Discontinuation of the FR-A800-GF Inverters and the FR-A8NCE Plug-in Option

Date of issue	March 2026	Title	Discontinuation of the FR-A800-GF Inverters and the FR-A8NCE Plug-in Option	Mitsubishi Electric Corp., Nagoya Works 5-1-14 Yada-minami, Higashi-ku, Nagoya 461-8670 Tel.: +81 (52) 721-2111 Main line
----------------------	------------	--------------	---	---

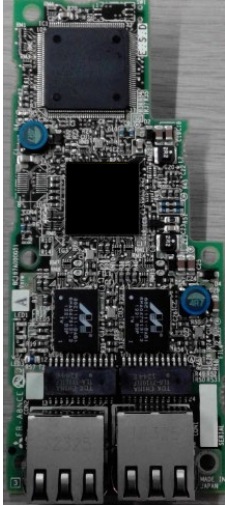
Item	FR-A8NCE (FR-A800-GF or FR-A802-GF)	FR-A8NCG (FR-A800-GN or FR-A802-GN)																
Appearance of the plug-in option	 <p>* Station number switches are not provided.</p>	 <p>1) Switch assembly for user setting (SW1)</p> <table border="1" data-bbox="1141 651 1465 752"> <thead> <tr> <th>State</th> <th>Communication mode</th> </tr> </thead> <tbody> <tr> <td>OFF</td> <td>CC-Link IE TSN</td> </tr> <tr> <td>ON</td> <td>CC-Link IE Field Network</td> </tr> </tbody> </table> <p>2) Station number switches (Setting is not required when the station number is set in Pr.435.)</p>	State	Communication mode	OFF	CC-Link IE TSN	ON	CC-Link IE Field Network										
State	Communication mode																	
OFF	CC-Link IE TSN																	
ON	CC-Link IE Field Network																	
LED display cover	<p>Used for CC-Link IE Field Network only.</p> 	<p>Used for both CC-Link IE TSN and CC-Link IE Field Network.</p>
